# PIC16C74

## PIC16C74 Rev. A Silicon Errata Sheet

## Clarifications/Corrections to the Data Sheet:

**FIGURE 1: WRITES TO TIMER1 (EXTERNAL CLOCK / OSCILLATOR MODE)**

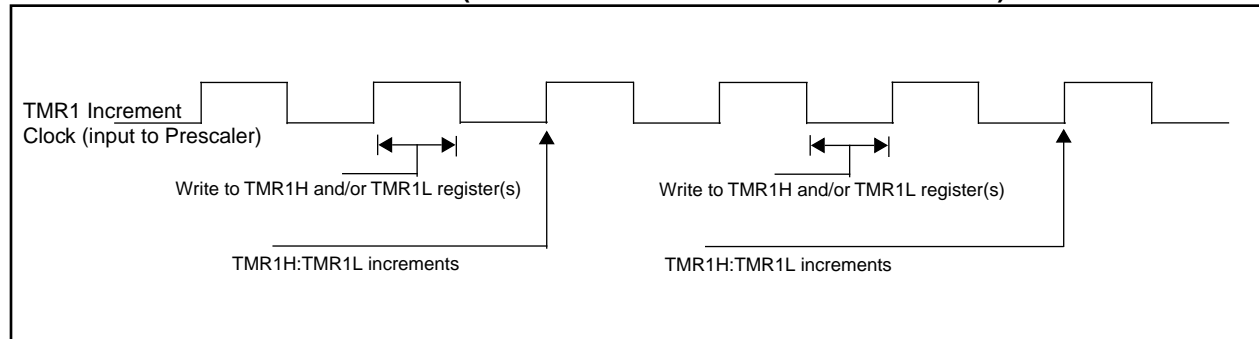
- a) The operation of Timer1 needs some clarification when the timer registers are written when the TMR1ON bit is set.

The internal clock signal that is the input to the TMR1 prescaler affects the incrementing of Timer1 (TMR1H:TMR1L registers and the Timer1 prescaler). When the Timer1 registers are NOT written, the Timer1 will increment on the rising edge of the TMR1 increment clock.

When the TMR1H and/or TMR1L registers are written while this clock is high, TMR1 will increment on the next rising edge of this clock.

When the TMR1H and/or TMR1L registers are written while this clock is low, TMR1 will not increment on the next rising edge of this clock, but must first have a falling clock and the the rising clock for TMR1 to increment.

Figure 1 shows the two cases of writes to the TMR1H and/or TMR1L registers. Due to the  $V_{IH}$  and  $V_{IL}$  thresholds on the oscillator/clock pins, external Timer1 oscillator components, and external clock frequency, the Timer1 increment clock may not be of a 50% duty cycle.

The TMR1 increment clock is out of phase of the T1OSO/T1CKI pin by a small propagation delay.
